**ZONING MAP CHANGE
STAFF REPORT**

City Council Meeting Date:
September 15, 2015

Request: From: "MU-2" High Intensity Mixed-Use
To: "PD/MU-2" Planned Development for all uses in "MU-2" High Intensity Mixed Use allowing a single use building to have a maximum 85 ft. height, 0' rear yard, including façade variation for two scaling elements, low e efficient glass, integrated mechanical shading/glazing or other thermal light heat energy measure, metal, porcelain, spandrel panels or curtain walls for masonry requirement and utilize landscaping architectural elements for screening parking garage facade; site plan included

COMPARISON OF MU-2 DEVELOPMENT PRINCIPLES AND PROPOSED PD/MU-2 WAIVERS ZC-15-124

AI **SITE PLAN- PROPOSED**
 ASI00 1"= 50'-0"

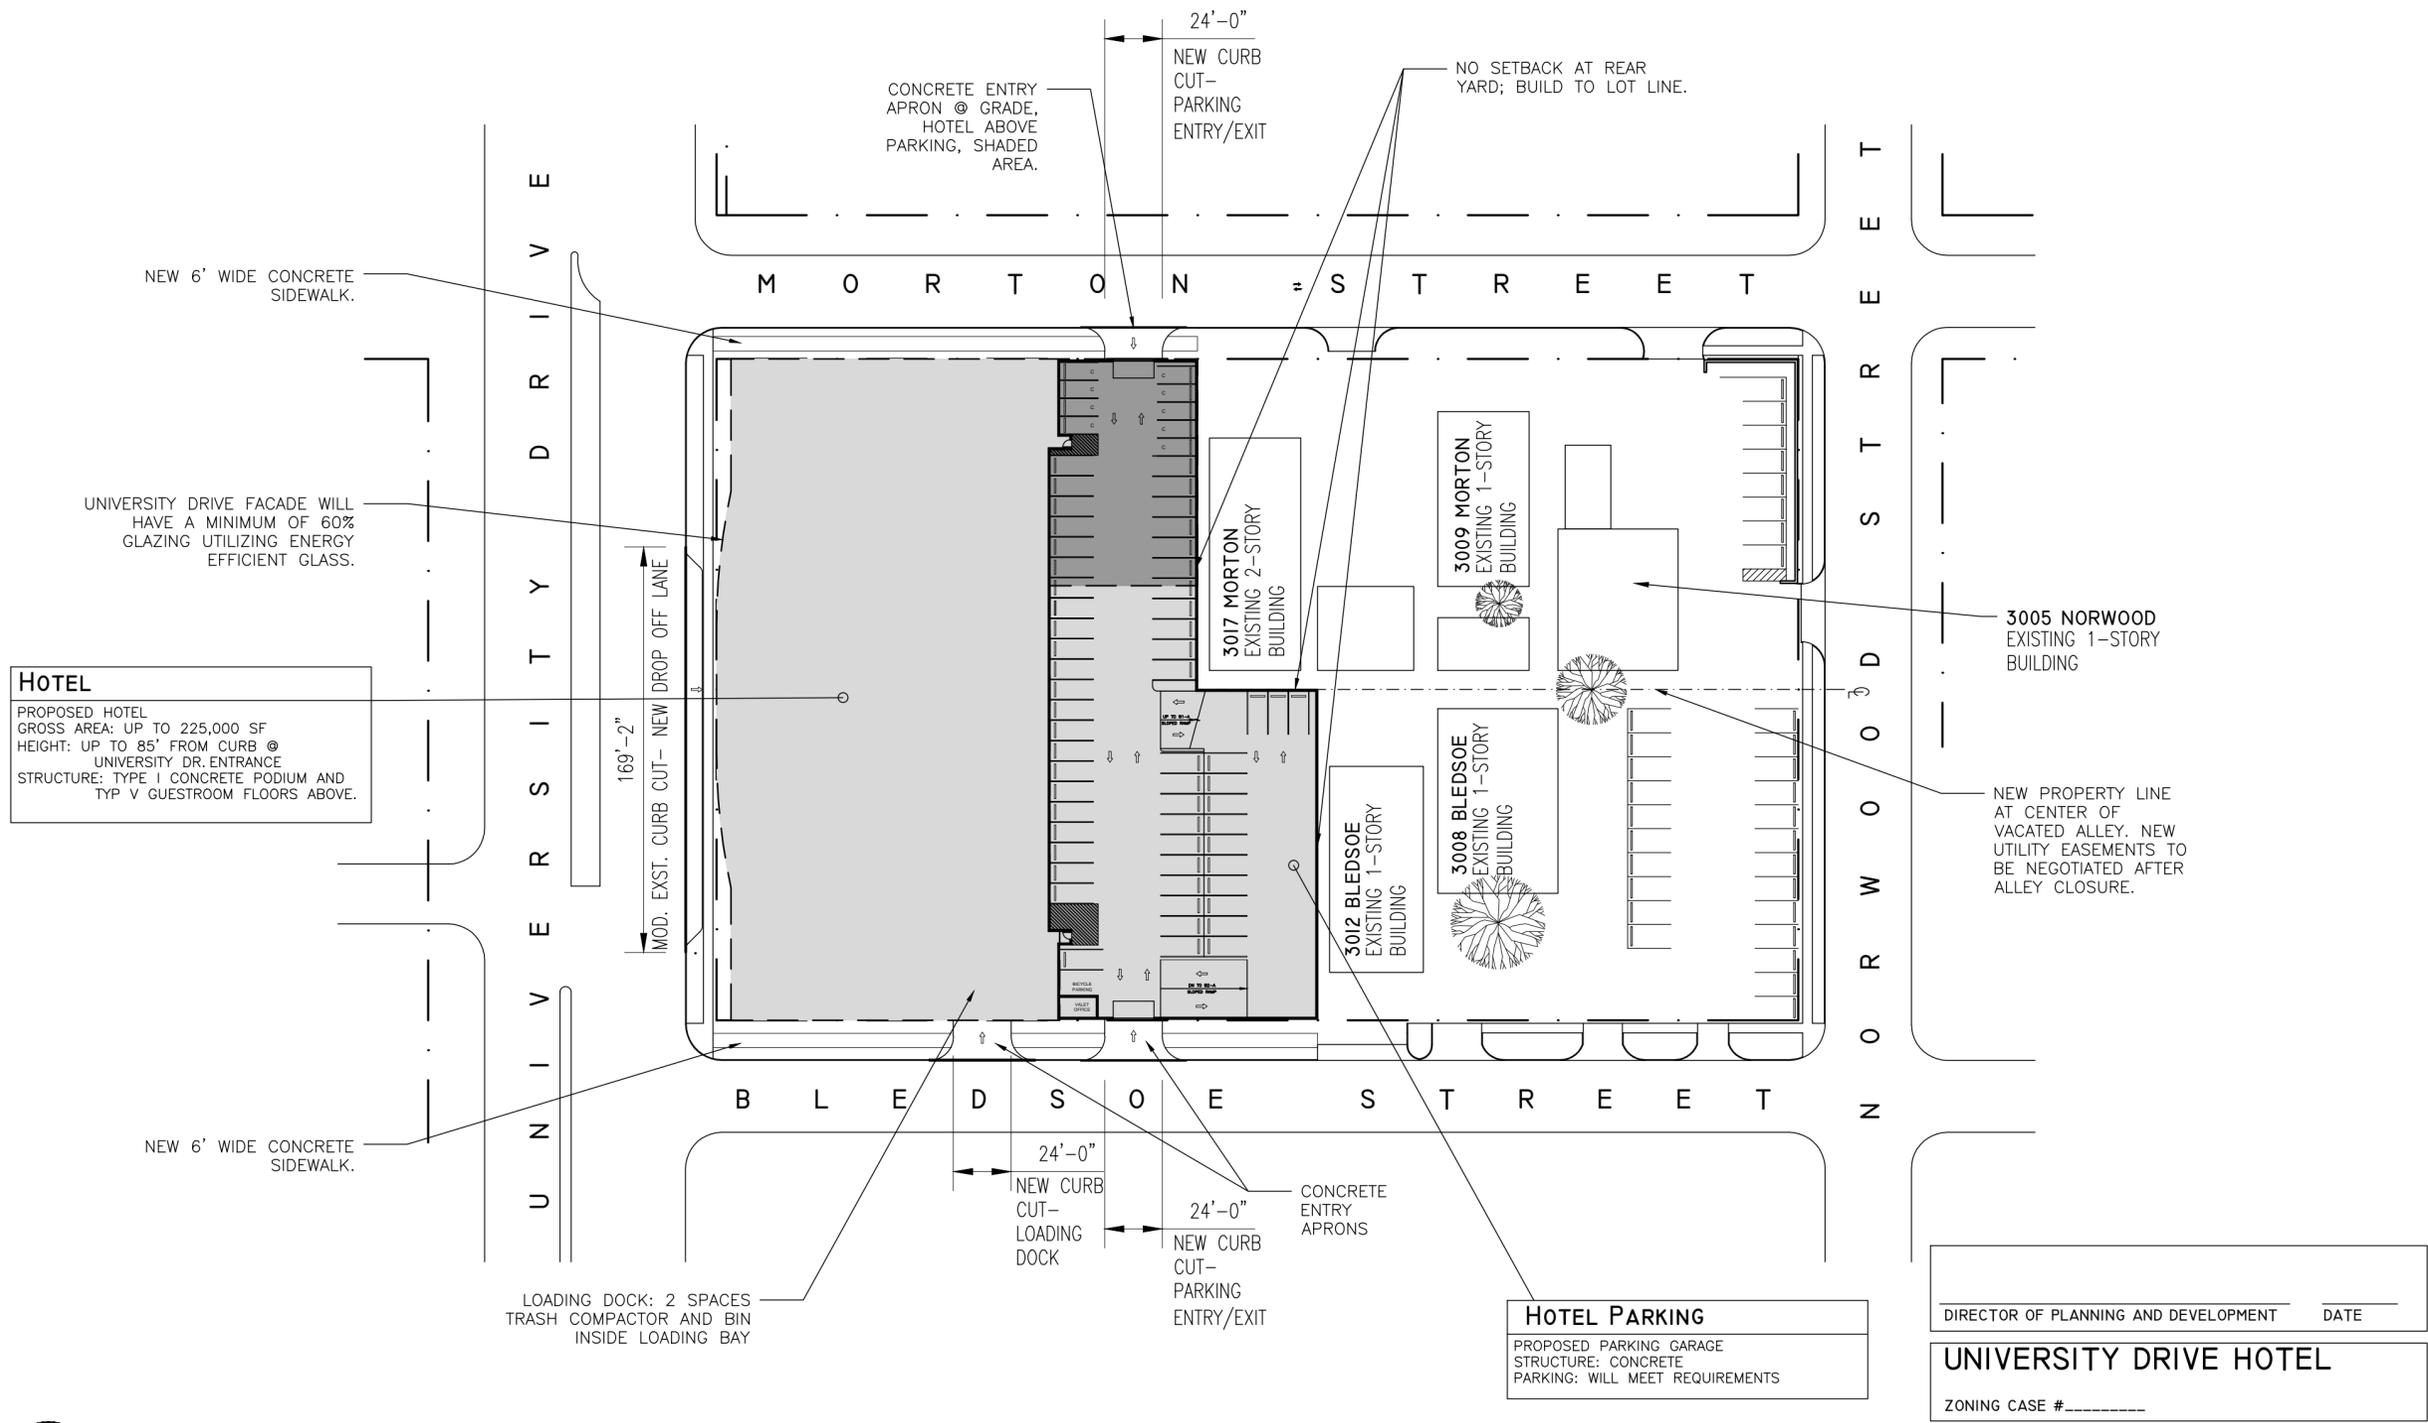
Site Plan Comments:

The applicant is requesting the following waivers to the zoning regulations (see Urban Design report for further information related to these waivers).

1. Rear Yard Setback
2. Maximum Height
3. Façade Design Standards for New Construction
 - a. Façade Variation, Scaling Elements
4. Fenestration
5. Building Materials
6. Parking Structure Façade Standards

Zoning Commission recommended waivers to the items noted above.

Comments made by TPW staff cannot be waived through the Zoning Commission. Approval of the site plan does not constitute TPW acceptance of conditions; traffic code will be applied to the project
